Work Order ID 143983

DESIGN #	DRAWN BY CP	DART AEROSPACE LTD HAWKESBURY, ONTARIO, CANADA	
CHECKED #	APPROVED #	DRAWING NO. D3166	REV. A SHEET 1 OF 1
DATE 02.07.10		TITLE BASKET HOOP	SCALE NTS
A	02.07.10	NEW ISSUE	
A1	04.04.08	38+/- WAS 36.0

D3166-1 BASKET HOOP

DRAWING NO. D3166	TITLE BASKET HOOP	REVA1	DART AEROSPACE LTD ENGINEERING ORDER		D.E.O. NO. D3166-A-2	SHEET NO. 1 OF 1	SCALE NTS
DRAWN AJS	CHECKED <i>[Signature]</i>	MFG. APPR. <i>[Signature]</i>	APPROVED <i>[Signature]</i>		DE APPR. <i>[Signature]</i>		
DATE 08.12.11	DATE 08.12.15	DATE 08/12/15	DATE 08/12/16		DATE 08.12.16

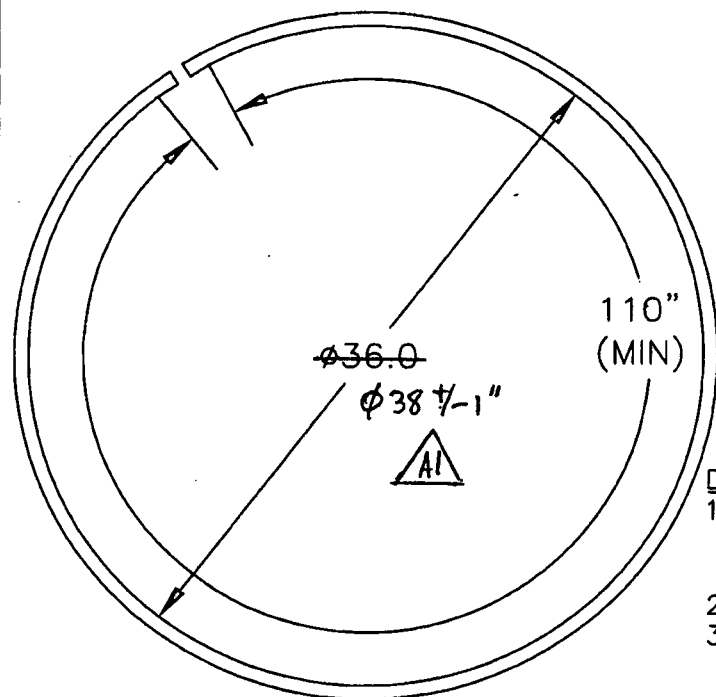
1) MODIFY MATERIAL NOTE FOR D3166-1 AS SHOWN:

2) MODIFY MATERIAL NOTE FOR D3166-3 AS SHOWN:

REASON: SEE PAR 08-005

IS:

1) MATERIAL: AISI 304/316 SS, 3/4 X 3/4 X 0.065 WALL SQUARE TUBING,
60.00" LONG
REF. DART SPEC M304TS0.750W.065

IS:

1) MATERIAL: AISI 304/316 SS, 3/4 X 3/4 X 0.065 WALL SQUARE TUBING,
120.00" LONG
REF. DART SPEC M304TS0.750W.065
